August 18, 2014

**Re: Rochester STP BRF 0162(19)**  
**Traffic Control Plan – Bridge # 13**

TOWN OF ROCHESTER  
COUNTY OF WINDSOR  
VT ROUTE 73 (RURAL MAJOR COLLECTOR), BRIDGE NO 13

Figure 6H-10. Lane Closure on a Two-Lane Road Using Flaggers (TA-10)

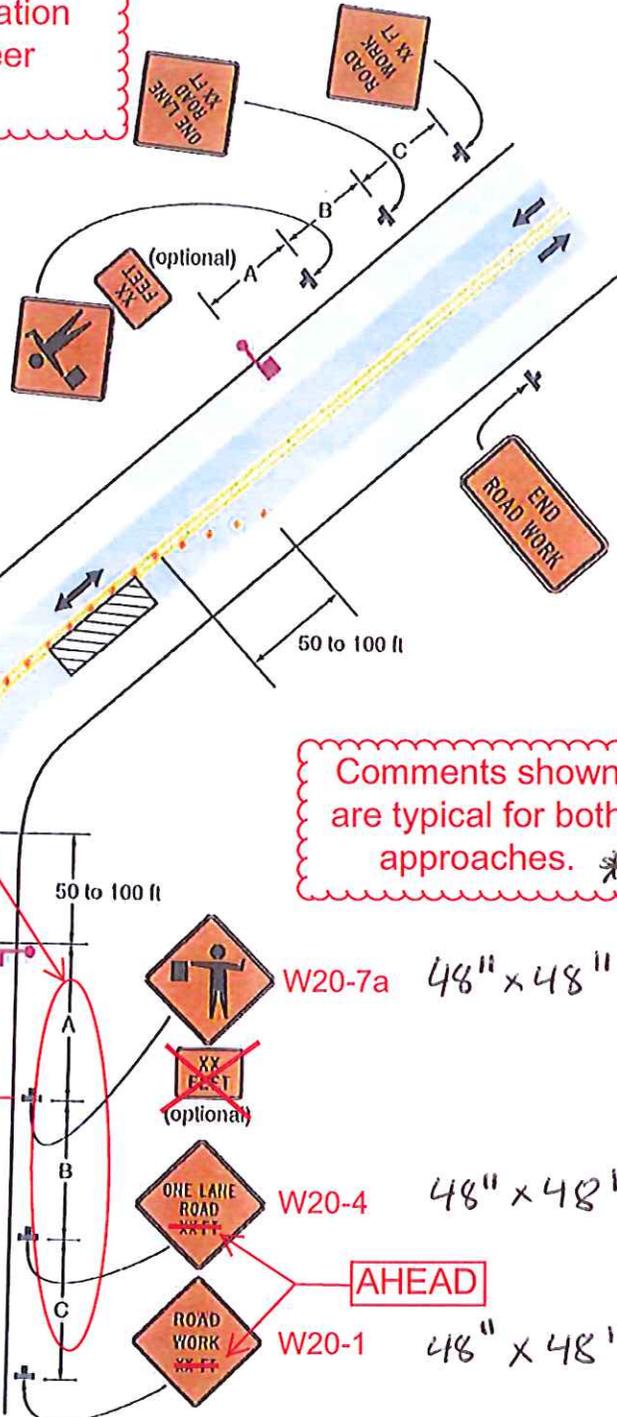
~~Will Traffic Cones be used. If not then remove~~

Please provide dimensions

500' spacings

LOCAL TRAFFIC CONTROL PLAN  
NOT TO SCALE

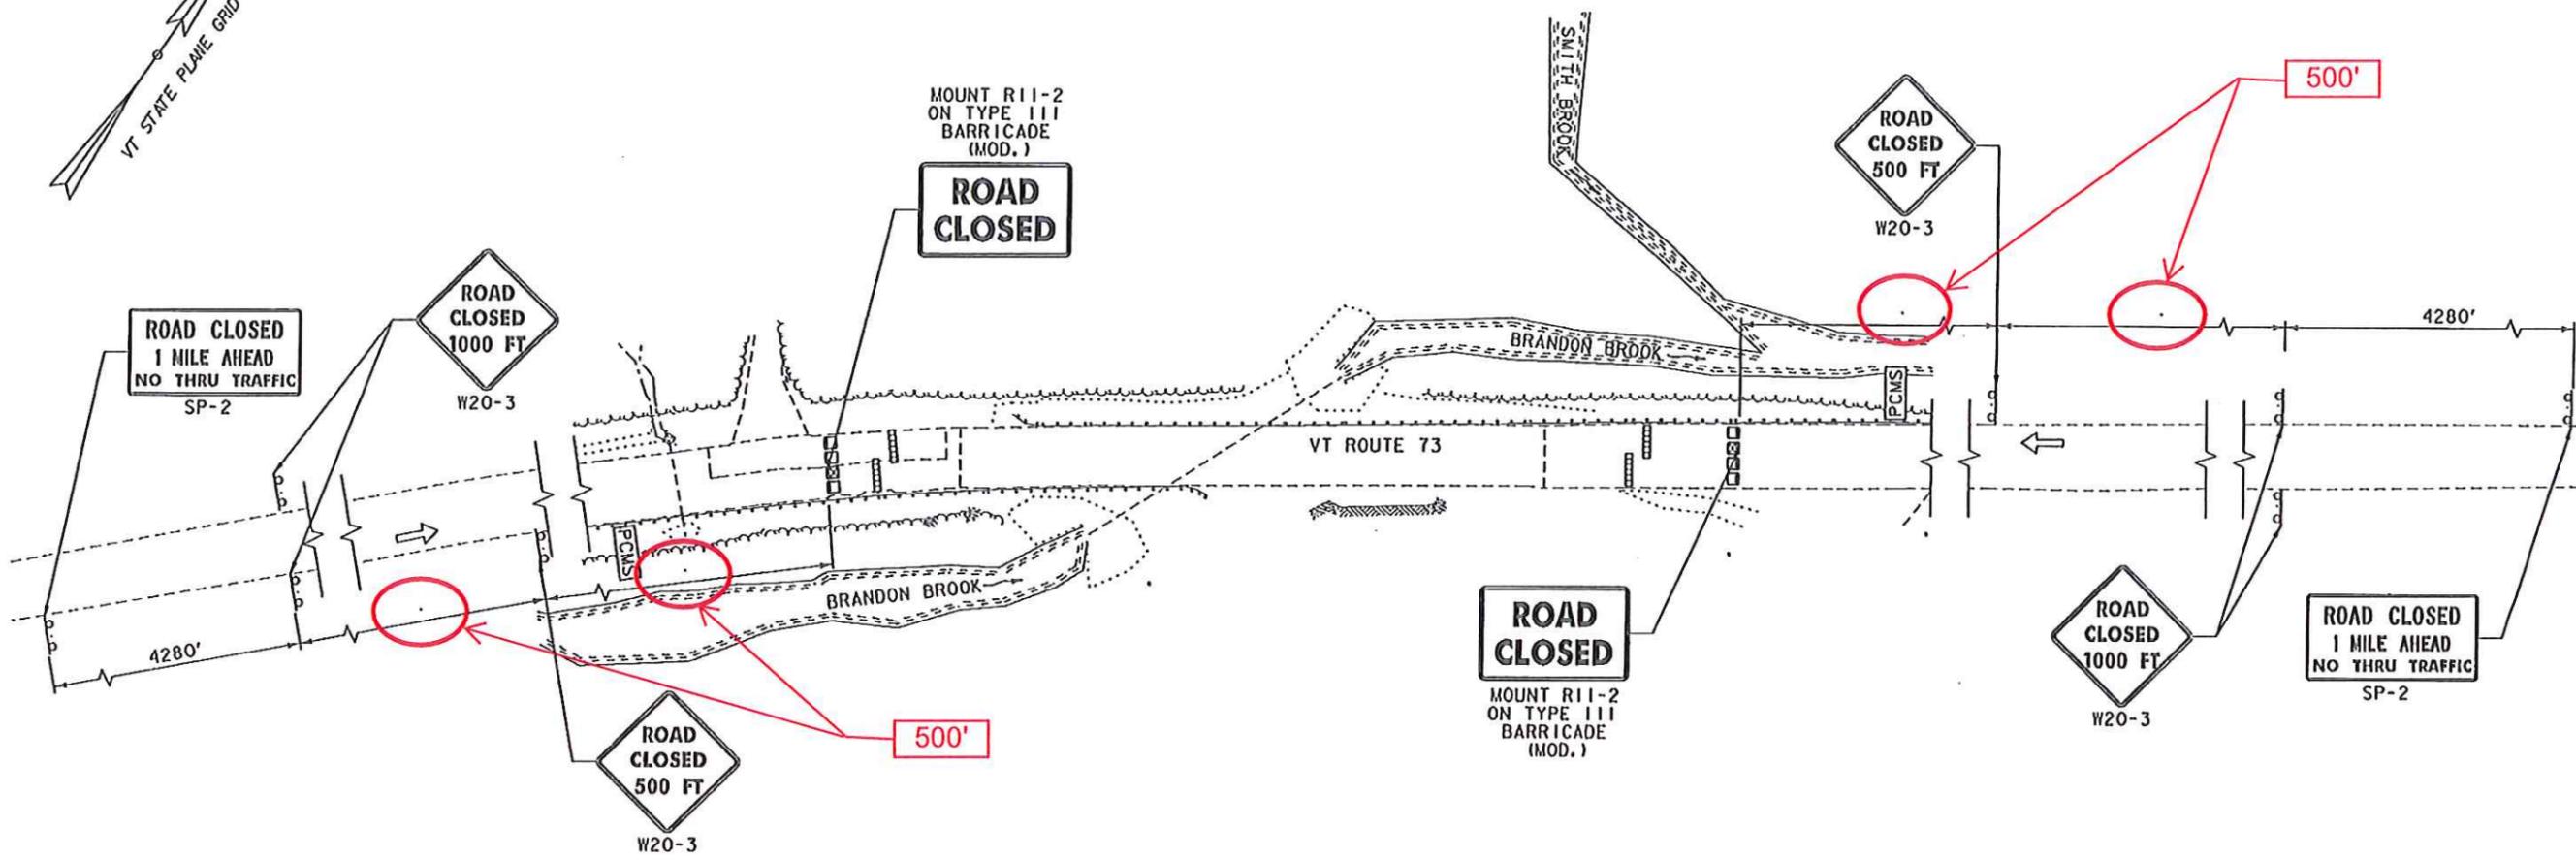
Move G20-2A so it is located opposite W20-7a sign

Comments shown are typical for both approaches. \*

Please provide dimensions of signs to be used or add a note that sign dimensions shall be as those shown on Sheet 193 of the Contract Plans.

REGIONAL TRAFFIC CONTROL PLAN

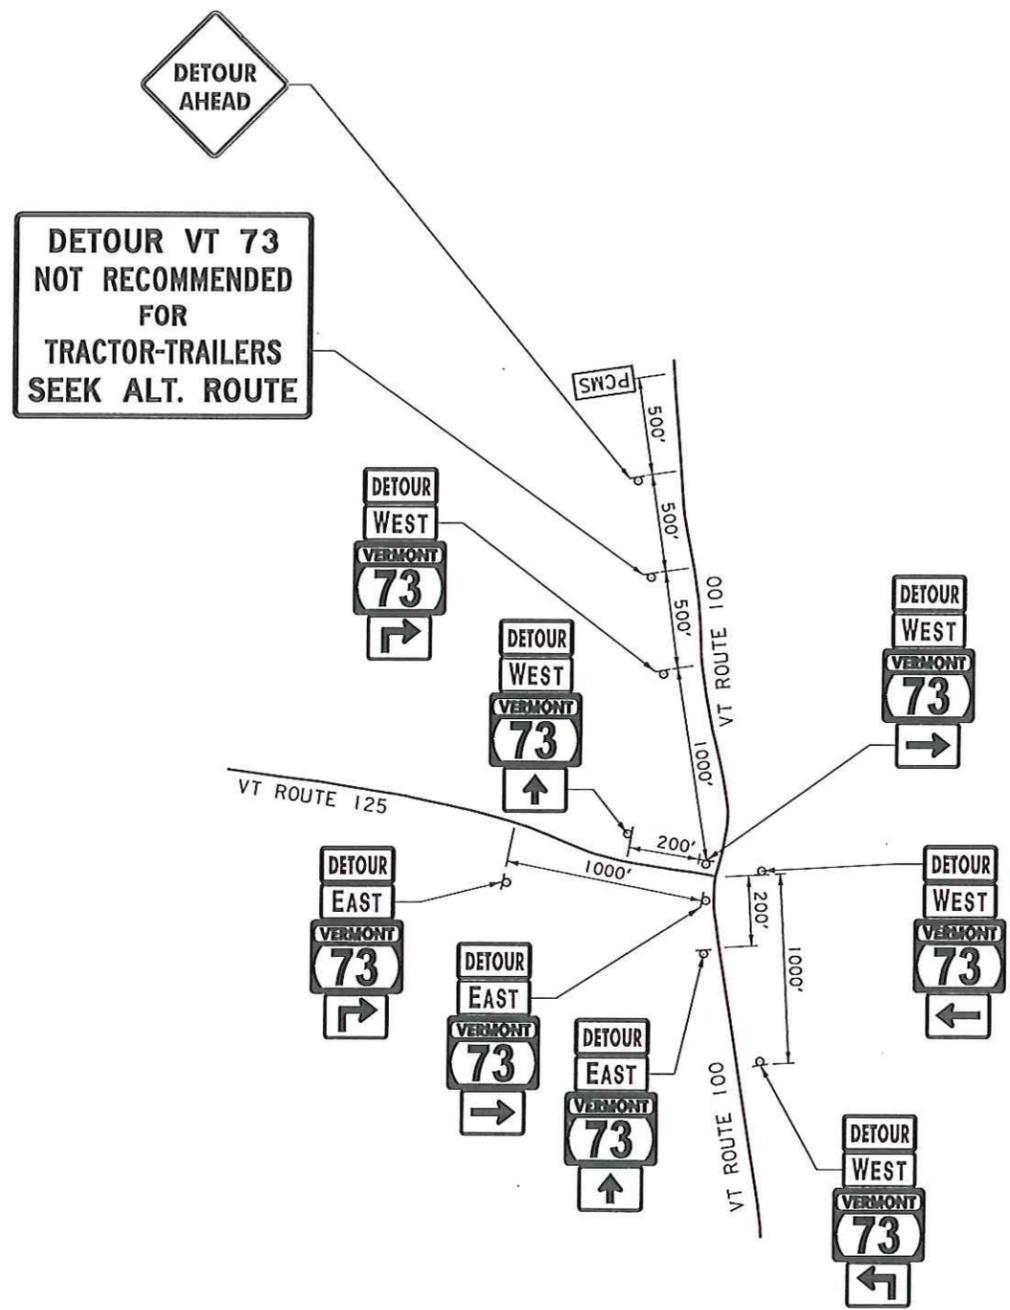
Add Additional SP -2 Sign from Sheet 30 of the Contract Plans - "Road Closed 3 Miles Ahead No Thru Traffic" Place on the west or north side of Bridge 15 facing Westbound traffic prior to the intersection of VT Route 73 and Bingo Rd.

Add Additional SP -2 Sign from Sheet 30 of the Contract Plans - "Road Closed 5 Miles Ahead No Thru Traffic" Place on VT 73 facing Westbound traffic prior to the intersection of VT Route 73 and Maple Hill Road.

PROJECT NAME: ROCHESTER	
PROJECT NUMBER: 0162(19), 0162(16), 0162(17), 0162(18)	
FILE NAME: z1c334Regionoldetour.dgn	PLOT DATE: 9/3/2013
PROJECT LEADER: S.E. BURBANK	DRAWN BY: E.A. FIALA
DESIGNED BY: S.E. BURBANK	CHECKED BY: S.E. BURBANK
REGIONAL TCP (3 OF 5)	SHEET 10 OF 238

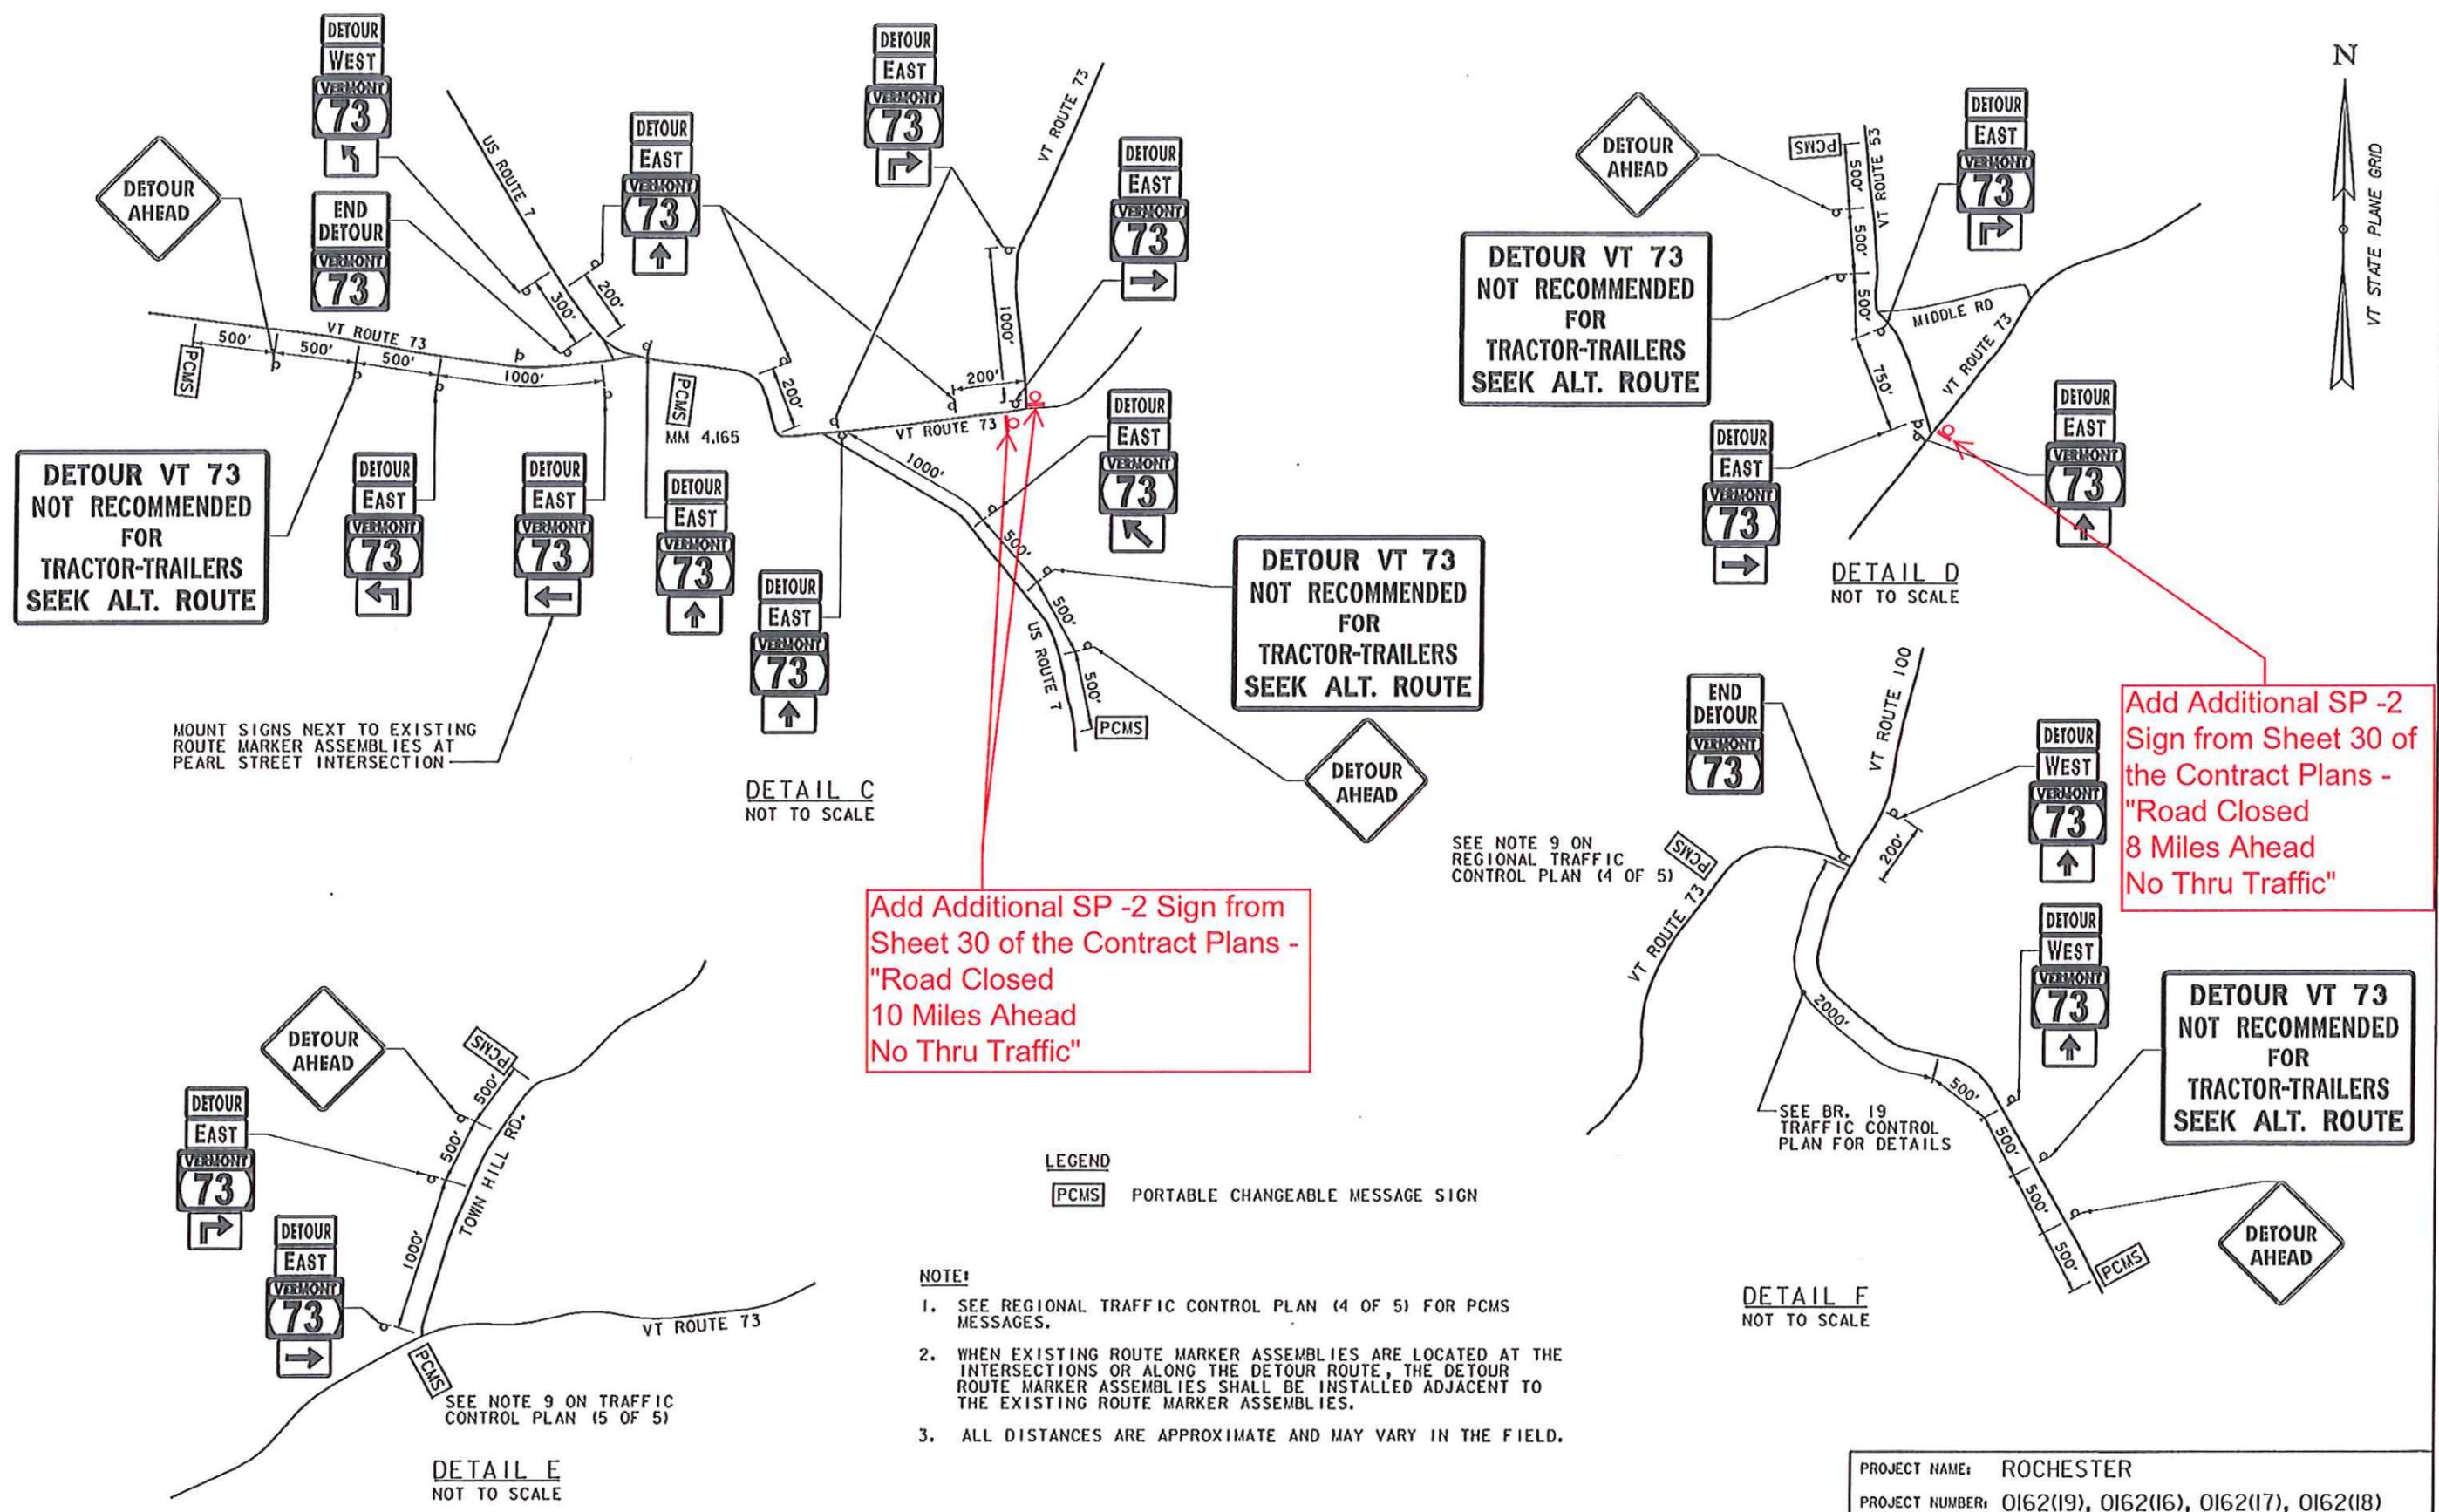
Add Additional SP -2 Sign from Sheet 30 of the Contract Plans - "Road Closed 8 Miles Ahead No Thru Traffic"

Add Additional SP -2 Sign from Sheet 30 of the Contract Plans - "Road Closed 10 Miles Ahead No Thru Traffic"
